END OF ADDENDUM NUMBER NO. 2

VAC Fit-Up – Phase 2

HDK Project No. 16110.00

ADDENDUM NO. E-01

Reference: Drawing E7, Emergency Lighting Battery Bank Schedule

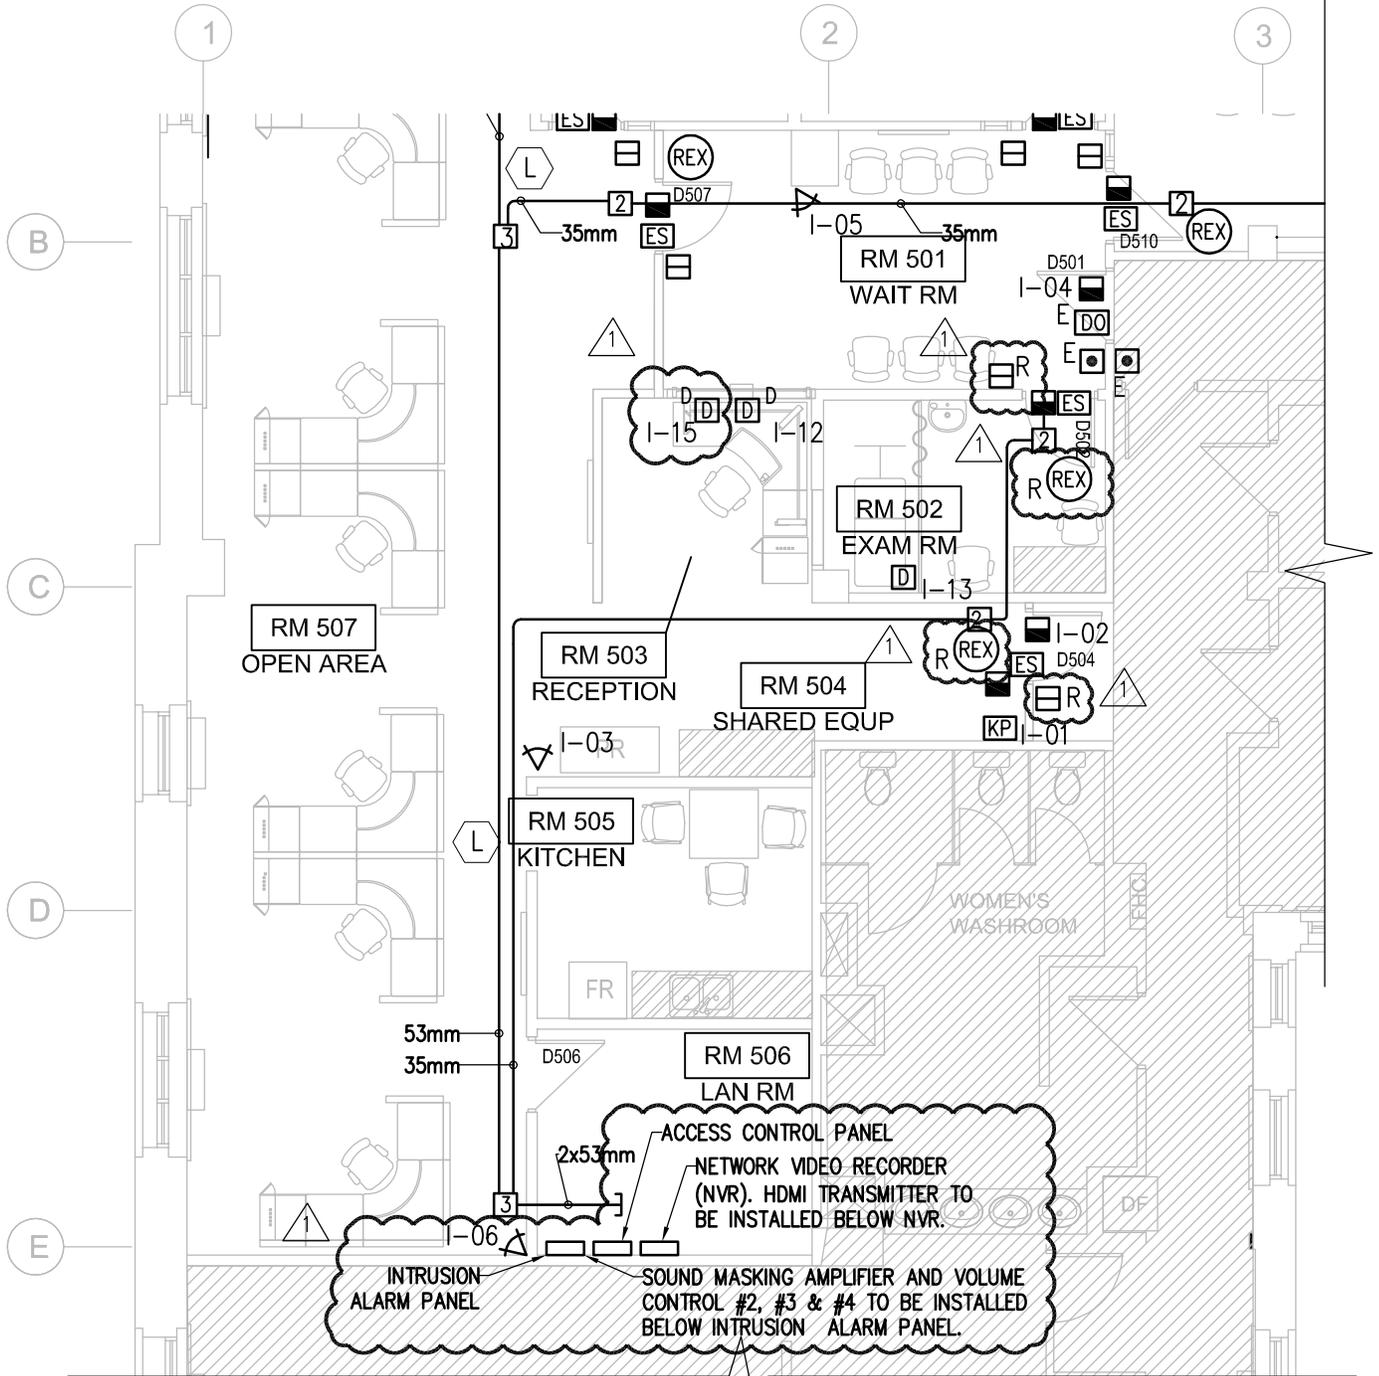
1. Revise battery unit as follows:
 - a. EB-1; Lumacell; RG12S-100-2-LD9-ATN-V-A; 5W3-9
2. Delete EB-2 and EB-3.
3. Delete note #3.

Drawn by	IS	PWGSC Project Manager April Reid		
Designed by	JS	Project no. R.080397.010		
Approved by	KO	Date	Sheet	Revision
		2016-12-12	T2R1

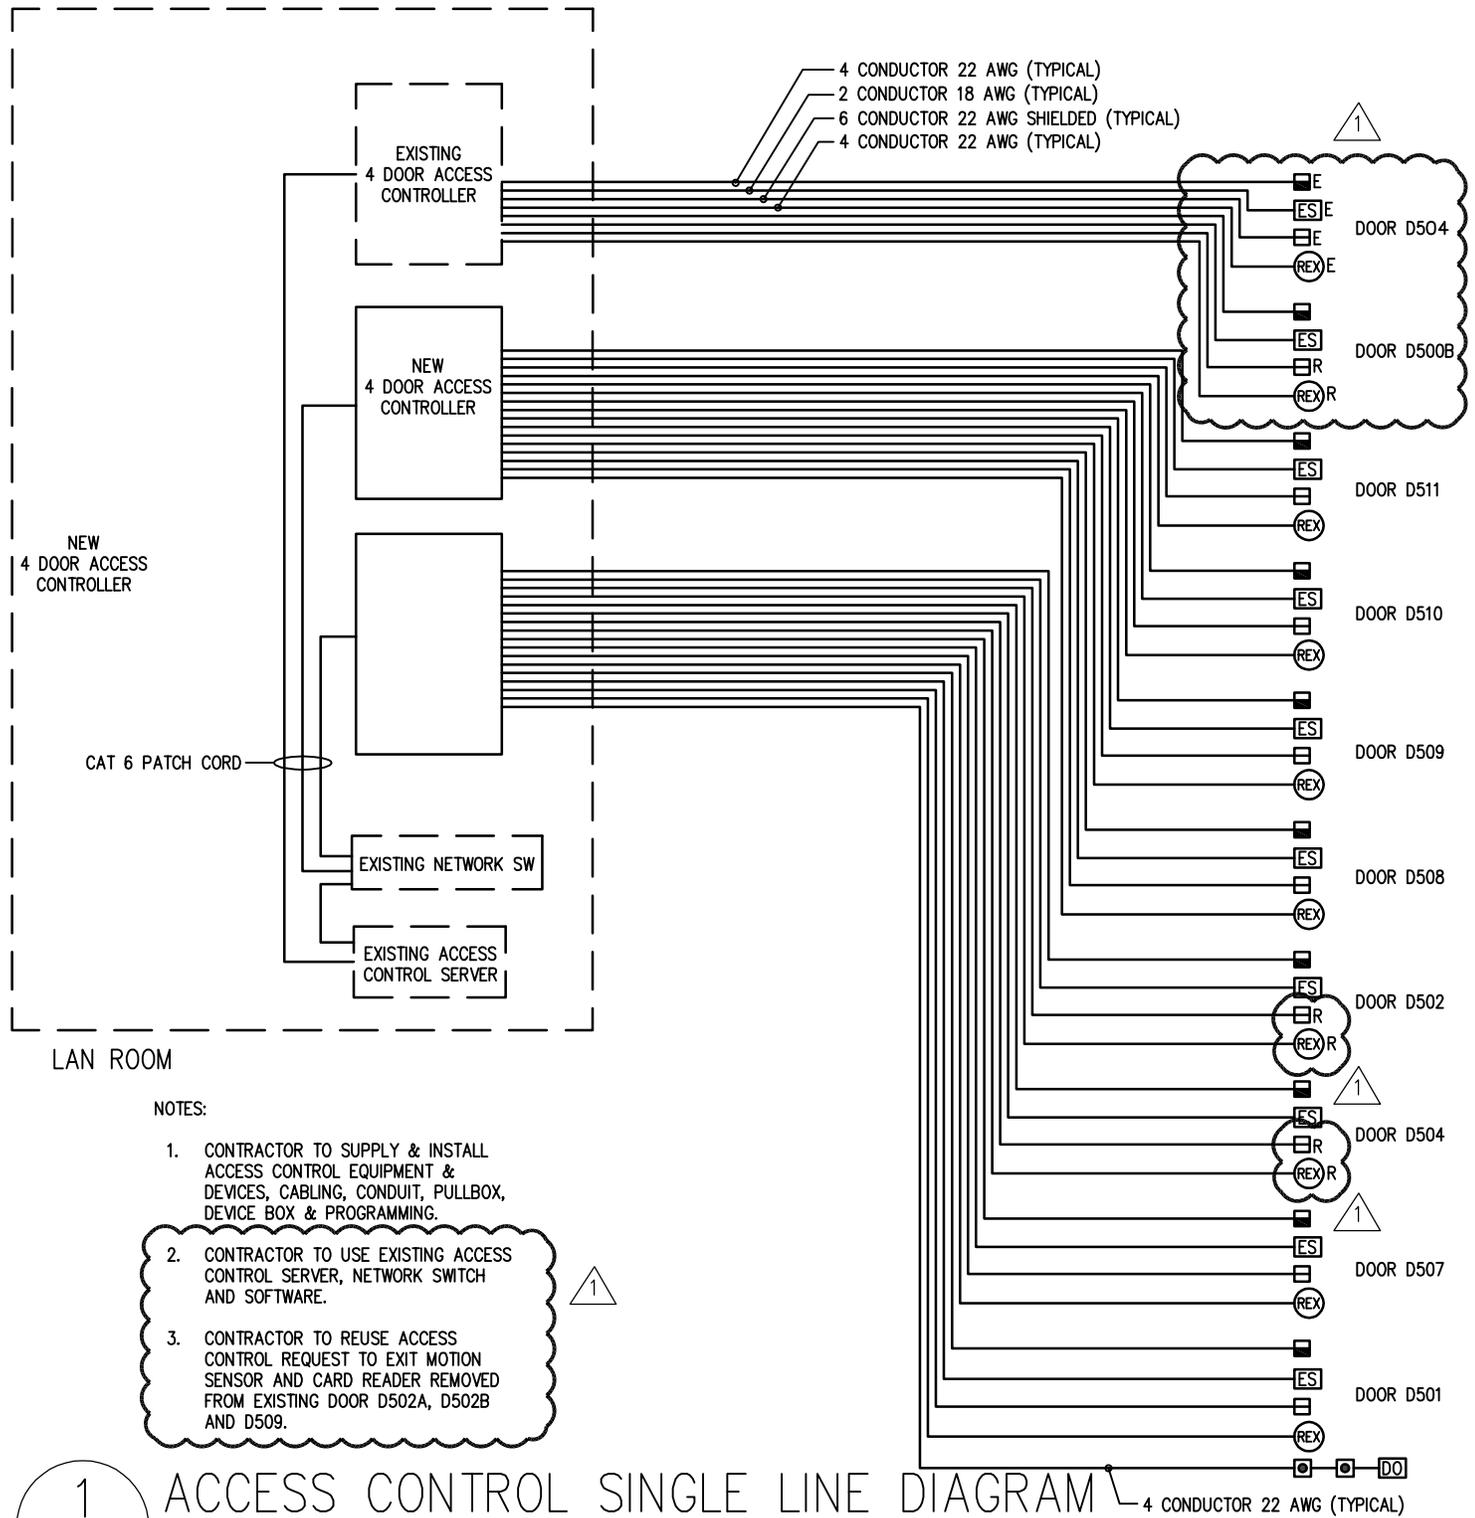
- .1 Drawing T2 & T3: **INSTALL** relocated access and control devices as indicated in part plan drawing T2R1 and T3R1.3.
- .2 Drawing T2 & T3: **REVISE** access control single line diagram. Refer to part plan drawing T3R1.1.
- .3 Drawing T2 & T3: **REVISE** intrusion alarm and video surveillance diagram. Refer to part plan drawing T3R1.2.
- .4 Drawing T2 & T3: **DELETE** devices as indicated in part plan drawing T3R1.4.

1. Install relocated access control devices as indicated in part plan drawing T2R1 and T3R1.3.
2. Revise access control single line diagram. Refer to part plan drawing T3R1.1.
3. Revise intrusion alarm and video surveillance diagram. Refer to part plan drawing T3R1.2
4. Delete devices as indicated in part plan drawing T3R1.4.
